**1958 Agreement – Consideration of draft amendments
to existing Regulations submitted by GRSP**

Proposal for Supplement 2 to Regulation No. 129 on Enhanced Child Restraint Systems (ECRS)

Submitted by the Working Party on Passive Safety*

Paragraph 4.5., the figure, amend to read:

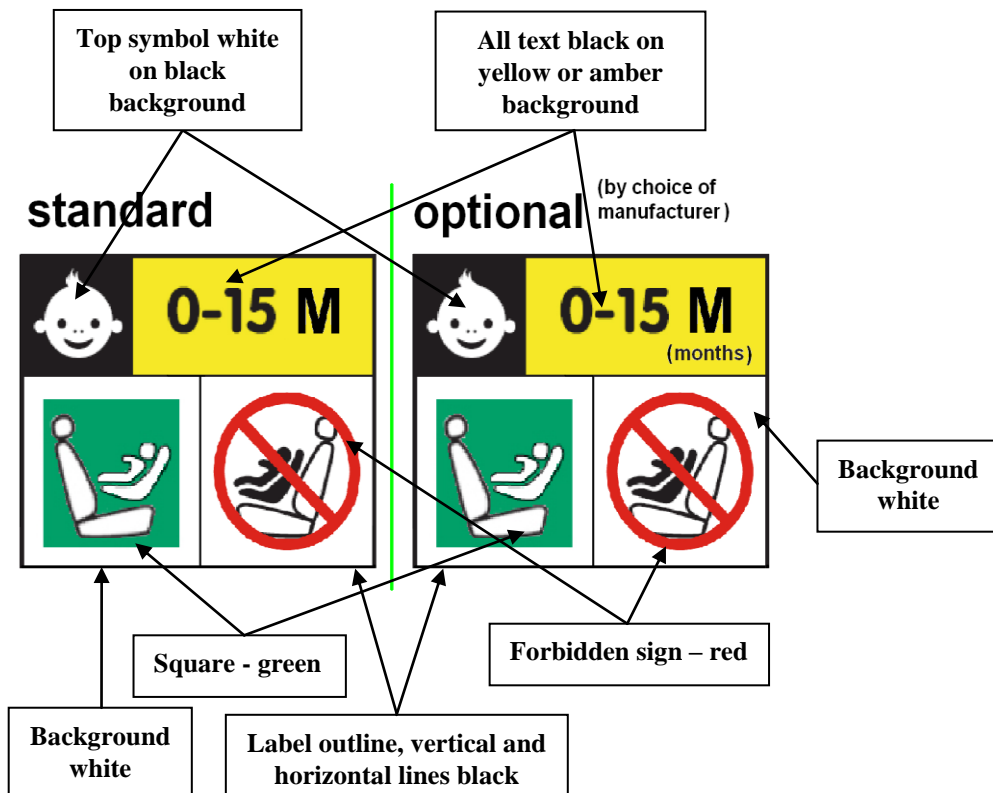
"4.5. In the case of ...
Minimum label size 40 x 40 mm

Paragraph 4.8., amend to read

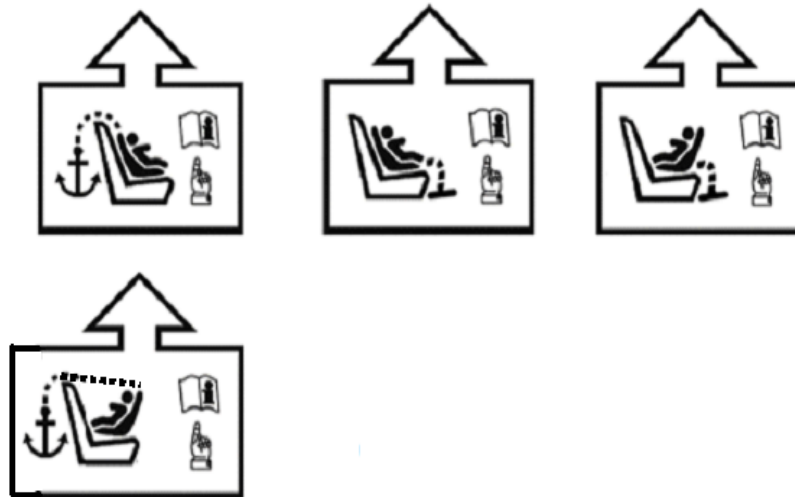
"4.8. Additional Marking

Figure 3

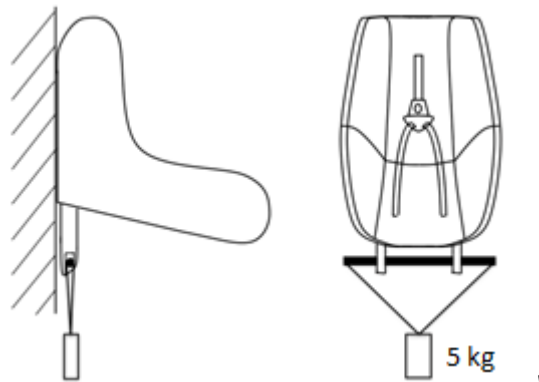
"7.2.8. The complete seat, or the component fitted with ISOFIX attachments (e.g. ISOFIX base) if it has a release button, is attached rigidly to a test rig in such a way that ISOFIX connectors are vertically aligned as shown in Figure 3. A 6 mm diameter bar, 350 mm long, shall be attached to the ISOFIX connectors. A mass of 5 kg shall be attached to the extremities of the bar.

7.2.8.1. An opening force shall be applied to the release button or handle along a fixed axis running parallel to the initial direction of motion of the button/handle; the geometric centre applies to that part of the surface of the ISOFIX attachment to which the release pressure is to be applied.

7.2.8.2. The ISOFIX attachment opening force shall be applied using a dynamometer or similar device in the normal manner and direction as indicated in the

manufacturers user manual. The contact end shall be a polished metal hemisphere with radius 2.5 ± 0.1 mm for a release button or a polished metal hook with a radius of 25 mm.

"Annex 2

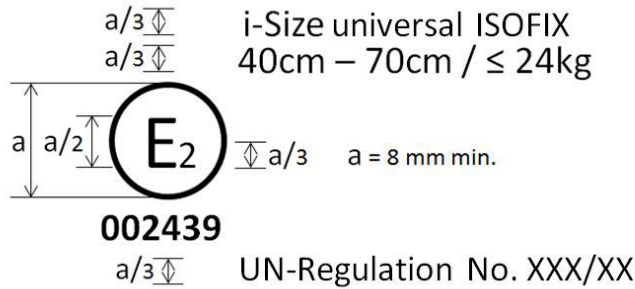
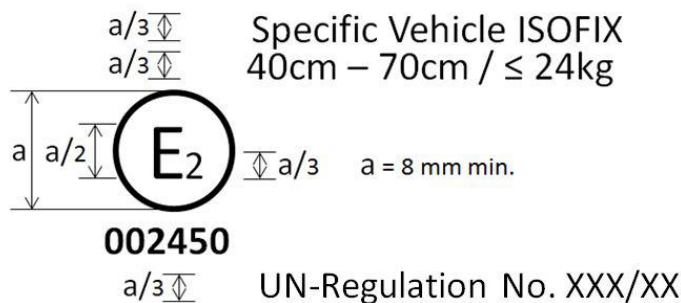
Annex 2, amend to read:

The child restraint system bearing the above approval mark is a device capable of being fitted in any i-size compatible vehicle seating position and of being used for the 40 cm to 70 cm size range and mass limit of 24 kg; it is approved in France (E2) under the number 002439. The approval number indicates that the approval was granted in accordance with the requirements of the Regulation concerning the approval of enhanced Child Restraint Systems used onboard of motor vehicles as amended by the 00 series of amendments. In addition the name of the regulation has to be identified on the approval mark followed by the series of amendment according to which the approval has been granted.

The child restraint system bearing the above approval mark is a device not capable of being fitted in every vehicle and of being used for the 40 cm to 70 cm size range and mass limit of 24 kg; it is approved in France (E2) under the number 002450. The approval number indicates that the approval was granted in accordance with the requirements of the Regulation concerning the approval of specific vehicle ISOFIX child restraint systems used on board of motor vehicles as amended by the 00 series of amendments. In addition, the name of the regulation has to be identified on the approval mark followed by the series of amendment according to which the approval has been granted.

"Figure 1

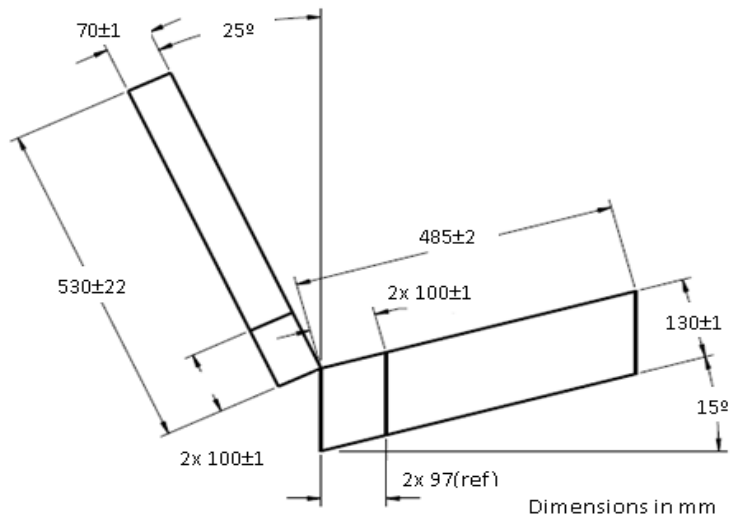
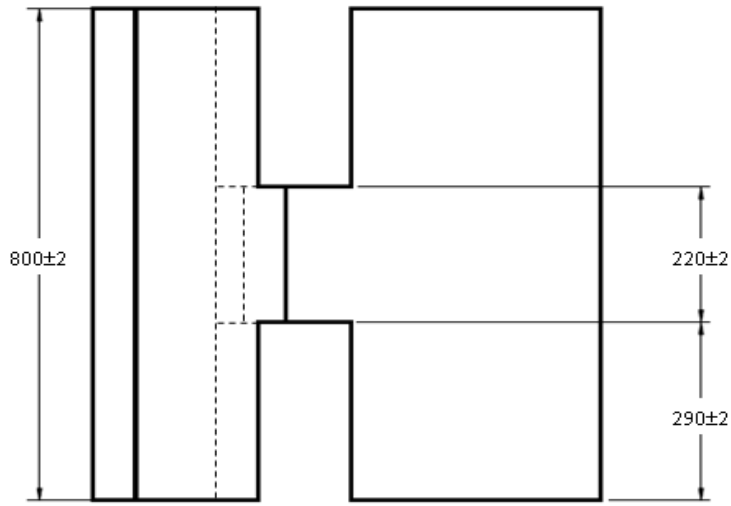
Figures 1 and 2, amend to read:

Dimensions of the seat and the seat cushions

"Figure 3
Dimensions of the cover material (dimensions in mm)

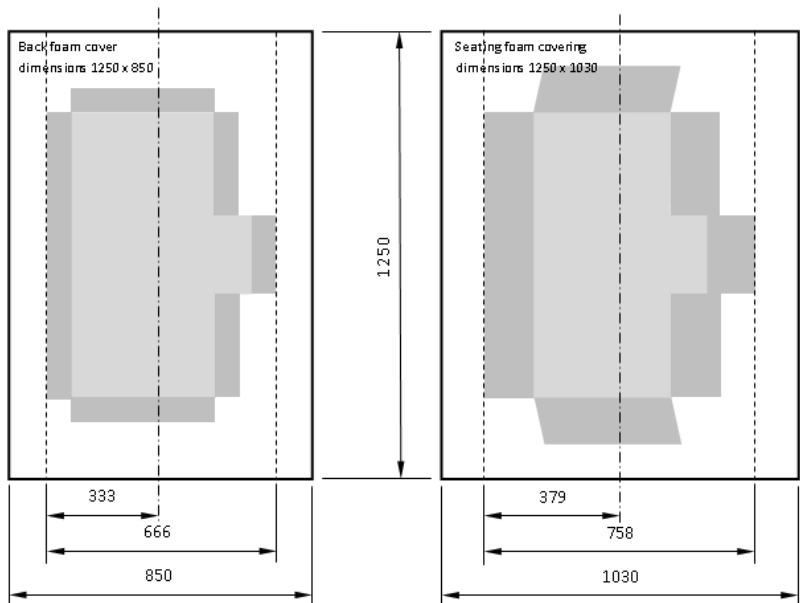
Figure 4 (former), renumber as Figure 3 and amend to read:

Figure 1
Side view of the support leg dimension assessment volume

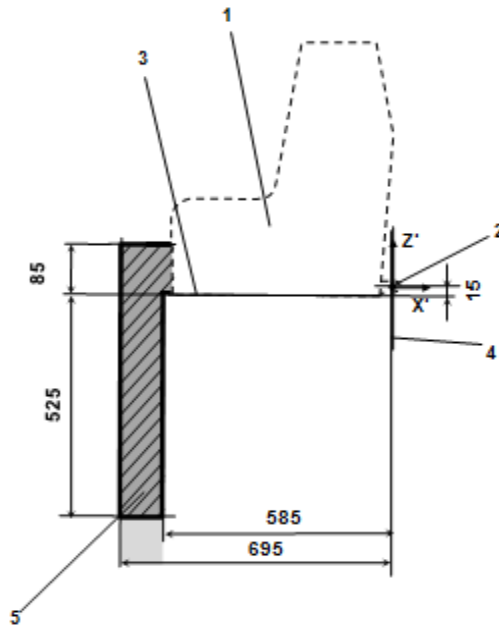
Annex 19, amend to read:

Figure 3
Side view of the support leg foot assessment volume

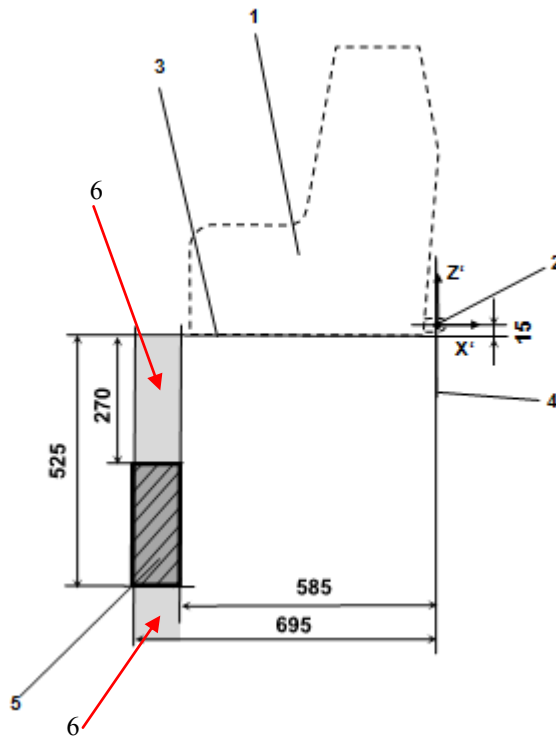
It shall be permissible for the support-leg to be adjustable beyond the height limits in the Z' direction (as indicated by key 6 in figure 3 of Annex 19), providing that no parts extend beyond the limiting planes in the X' and Y' directions.

Load application device I

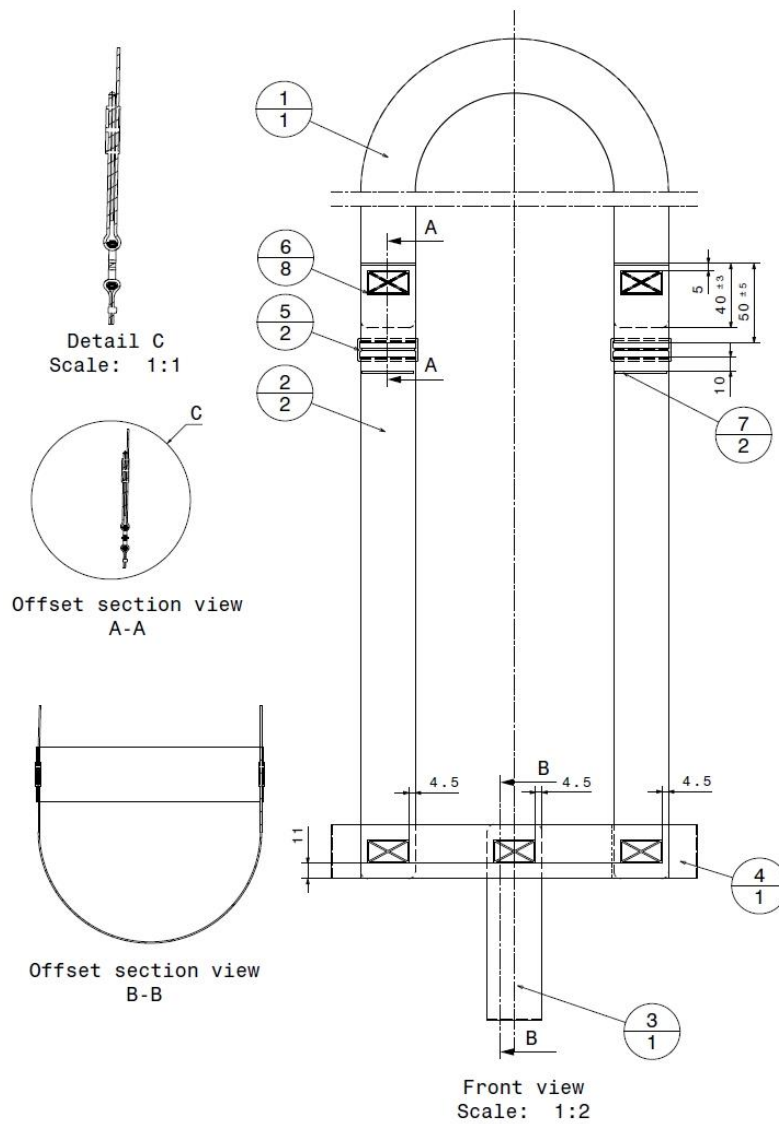
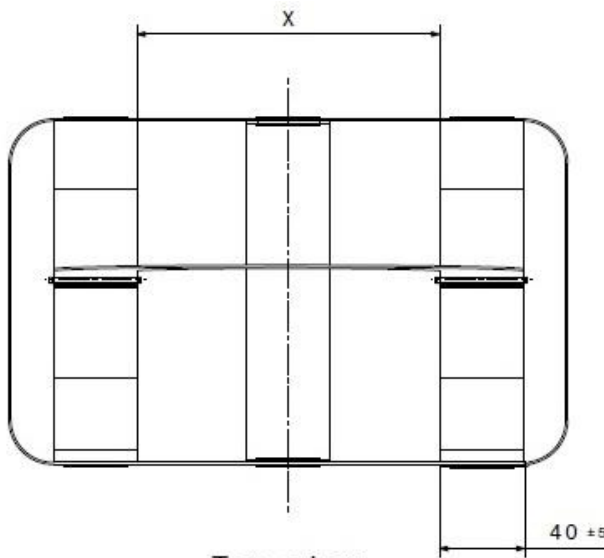
"7.1.2.1. The manikin shall be equipped with either of the load application devices as appropriate, and described in Annex 21. Place the manikin in the restraints installed in accordance with this Regulation and taking into account the manufacturer's instructions and with the standard slack as specified in paragraph 7.1.3.5., applied for all systems identically."

"7.1.2.3. At this static inverted position, a mass equivalent to four times that of the dummy shall be applied vertically downwards in a plane perpendicular to the axis of rotation in addition to the dummy utilizing the load application device described in Annex 21. The load shall be applied in a gradual controlled manner at a rate not exceeding gravitational acceleration or 400mm/min. Maintain the prescribed maximum load for a duration of 30 -0/+5 seconds.

Insert new Annex 21, to read:
